THIRTEEN OUTLAWS LLC HOPE PHYSICAL THERAPY-PARKING LOT

SITE DEVELOPMENT PLAN HOPE PHYSICAL THERAPY-PARKING LOT	THIRTEEN OUTLAWS, LLC	4850 AUSTIN BLUFFS PKWY COLORADO SPRINGS, CO 80918
# Date	Issue / Description	Init.
- - - - - - - - -		
Project No:		HPT01
Drawn By:		ASA/MRK
Drawn By: Checked By:		ASA/MRK CRD

V1_Site Development Plan 2.pdf Markup Summary

DETAIL GRADING

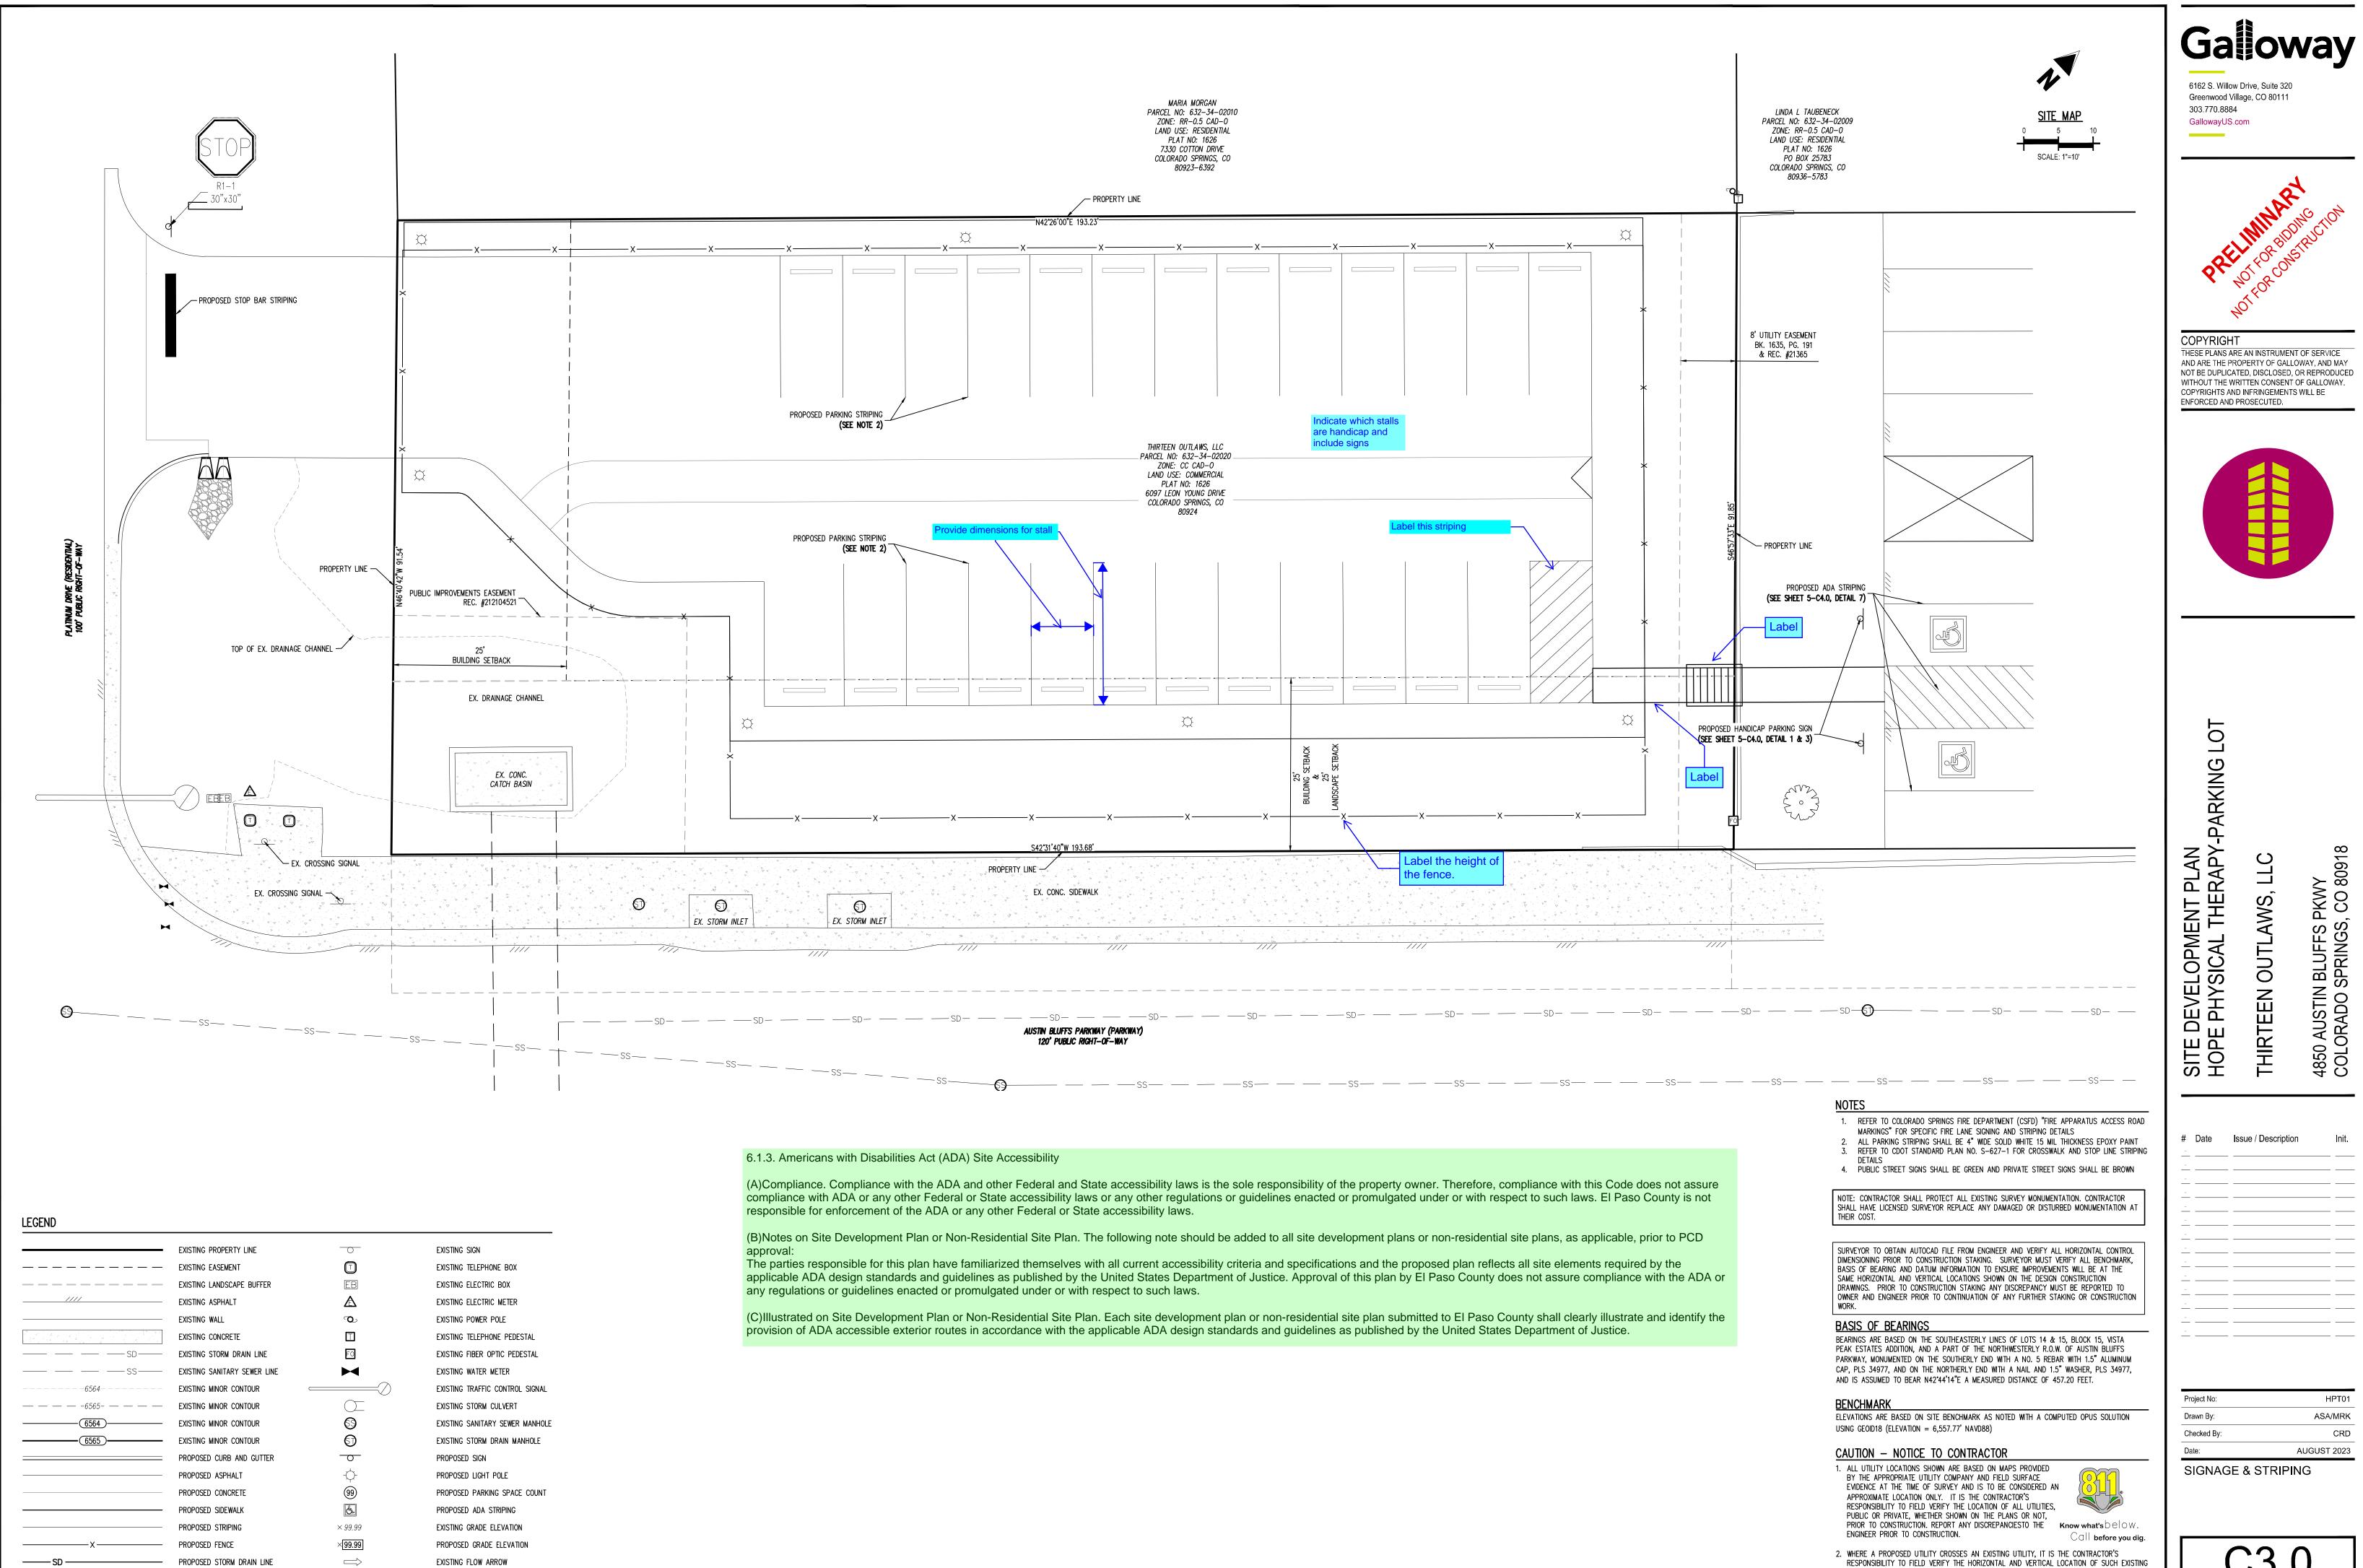
Labol hoadvall & provide detail 8- 5556	Subject: Callout Page Label: [3] 3 DETAIL GRADING Author: CDurham Date: 10/3/2023 2:57:31 PM Status: Color: Layer: Space:	Label headwall & provide detail
Proved emensions & deal protection	Subject: Callout Page Label: [3] 3 DETAIL GRADING Author: CDurham Date: 10/3/2023 2:57:20 PM Status: Color: Layer: Space:	Provide dimensions & detail for outlet protection
	Subject: Callout Page Label: [4] 4 SIGNAGE & STRIPING Author: CDurham Date: 10/3/2023 3:00:24 PM Status: Color: Layer: Space:	Provide dimensions for stall
	Subject: Callout Page Label: [4] 4 SIGNAGE & STRIPING Author: CDurham Date: 10/3/2023 3:00:40 PM Status: Color: Layer: Space:	Label this striping
	Subject: Callout Page Label: [3] 3 DETAIL GRADING Author: dotdurham Date: 10/3/2023 3:06:34 PM Status: Color: Layer: Space:	Provide invert elevations for culvert

ext Box (6)		
Label ROW	Subject: Text Box Page Label: [3] 3 DETAIL GRADING Author: CDurham Date: 10/3/2023 2:58:04 PM Status: Color: Layer: Space:	Label ROW
Label ROW	Subject: Text Box Page Label: [2] 2 HORIZONTAL CONTROL Author: CDurham Date: 10/3/2023 2:58:15 PM Status: Color: Layer: Space:	Label ROW
I Indicate which stalls are handicap and include signs	Subject: Text Box Page Label: [4] 4 SIGNAGE & STRIPING Author: CDurham Date: 10/3/2023 3:01:06 PM Status: Color: Layer: Space:	Indicate which stalls are handicap and include signs
List of a second	Subject: Text Box Page Label: [5] 5 SITE DETAILS Author: CDurham Date: 10/3/2023 3:02:50 PM Status: Color: Layer: Space:	Include detail for handrail
Where is this located? Please able on pain	Subject: Text Box Page Label: [5] 5 SITE DETAILS Author: CDurham Date: 10/3/2023 3:03:22 PM Status: Color: Layer: Space:	Where is this located? Please label on plan

Sheet 4 of 8

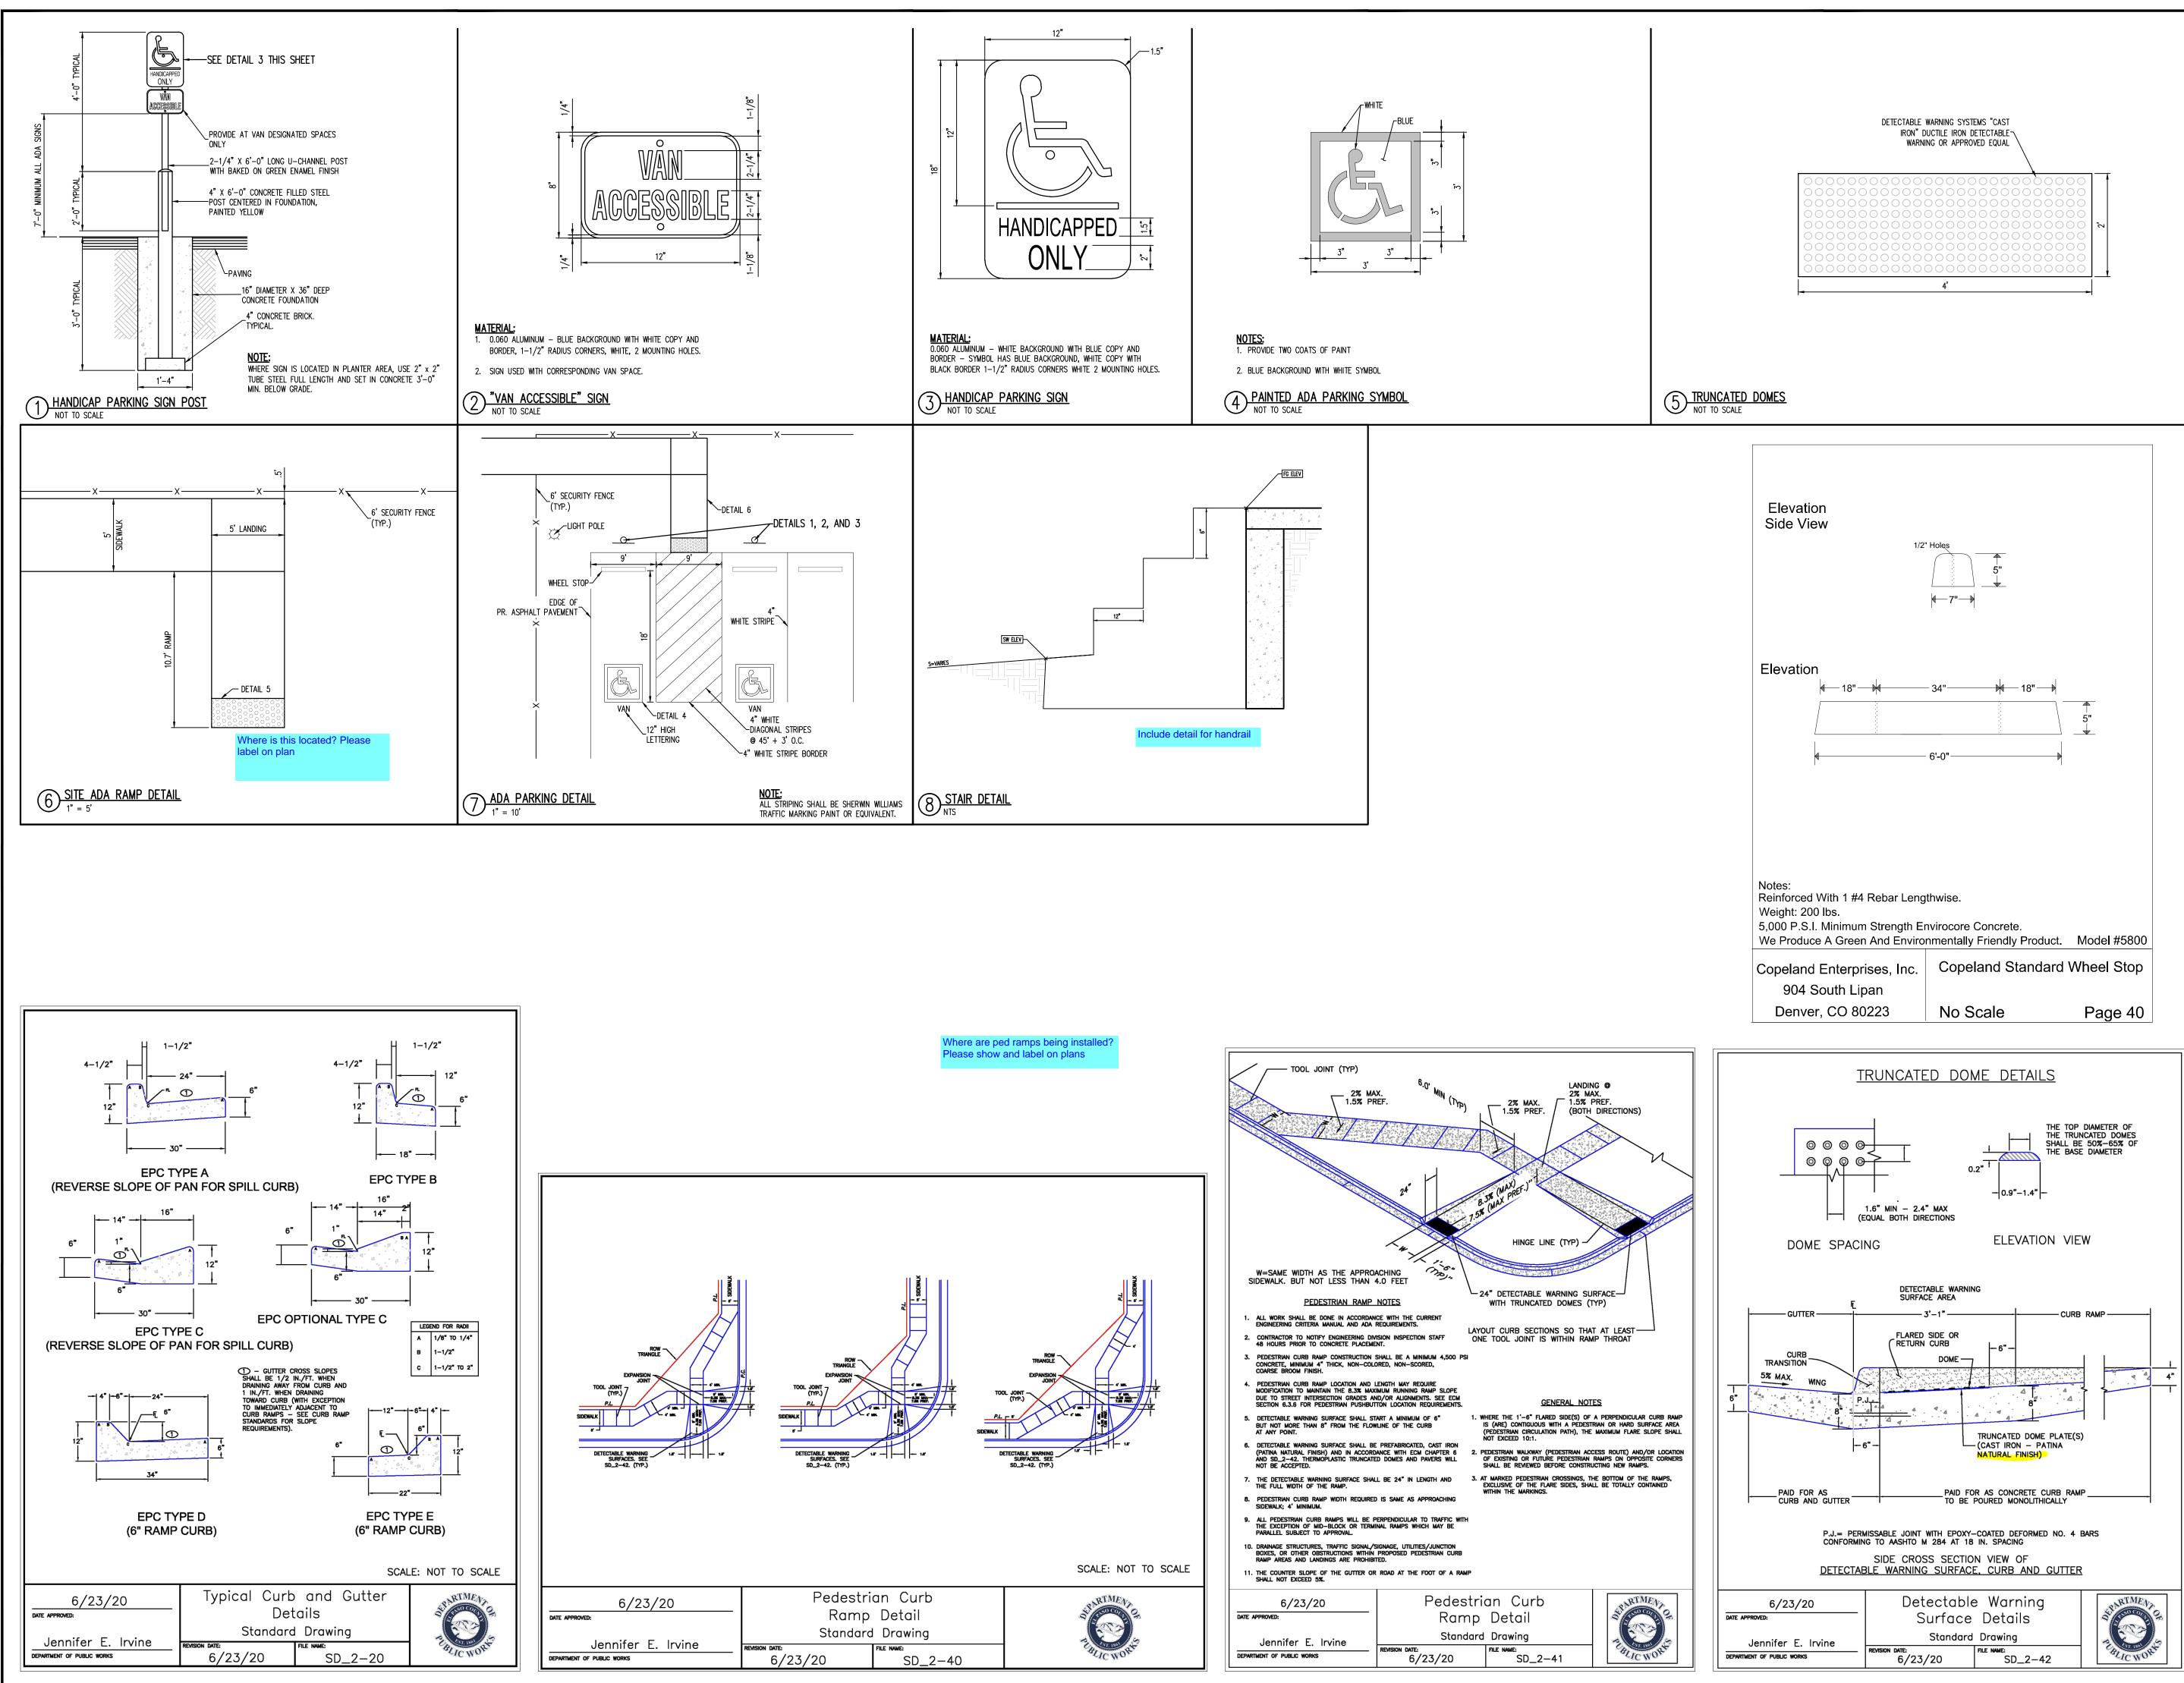
(SEE SHET 5-C4	Subject: Callout Page Label: [4] 4 SIGNAGE & STRIPING Author: Carlos Date: 9/26/2023 5:19:16 PM Status: Color: Layer: Space:	Label
Libel the height of the ferror.	Subject: Callout Page Label: [4] 4 SIGNAGE & STRIPING Author: Carlos Date: 10/2/2023 4:57:40 PM Status: Color: Layer: Space:	Label the height of the fence.
REPORT INVOLUP PA	Subject: Callout Page Label: [4] 4 SIGNAGE & STRIPING Author: Carlos Date: 10/2/2023 4:57:49 PM Status: Color: Layer: Space:	Label
Render For A process Band Townson The of D. BORNEZ OF	Subject: Callout Page Label: [2] 2 HORIZONTAL CONTROL Author: CDurham Date: 10/3/2023 2:52:48 PM Status: Color: Layer: Space:	Label tie-in & provide northing/easting
R 199 SP	Subject: Callout Page Label: [2] 2 HORIZONTAL CONTROL Author: CDurham Date: 10/3/2023 2:52:44 PM Status: Color: Layer: Space:	Label tie-in & provide northing/easting
B comp B comp C comp	Subject: Callout Page Label: [2] 2 HORIZONTAL CONTROL Author: CDurham Date: 10/3/2023 2:53:40 PM Status: Color: Layer: Space:	Label start & end of pan flowline. Include northing/eastings

Subject: Dimension Page Label: [4] 4 SIGNAGE & STRIPING Author: CDurham Date: 10/3/2023 2:59:25 PM Status: Color: Layer: Space: Subject: Dimension Page Label: [4] 4 SIGNAGE & STRIPING Author: CDurham Date: 10/3/2023 2:59:46 PM Status: Color: Layer: Space: Highlight (3) Subject: Highlight Page Label: [2] 2 HORIZONTAL CONTROL Author: CDurham PR. 15" ST Date: 10/3/2023 2:53:50 PM Status: Color: Layer: Space: Subject: Highlight Page Label: [2] 2 HORIZONTAL CONTROL PR. 18" FE Author: CDurham Date: 10/3/2023 2:53:52 PM Status: Color: 📒 Layer: Space: Subject: Highlight TRUNCATED DOME PLATI (CAST IRON - PATINA NATURAL FINISH) Page Label: [5] 5 SITE DETAILS Author: CDurham Date: 10/3/2023 3:04:23 PM D FOR AS CONCRETE CURB F Status: Color: Layer: Space:
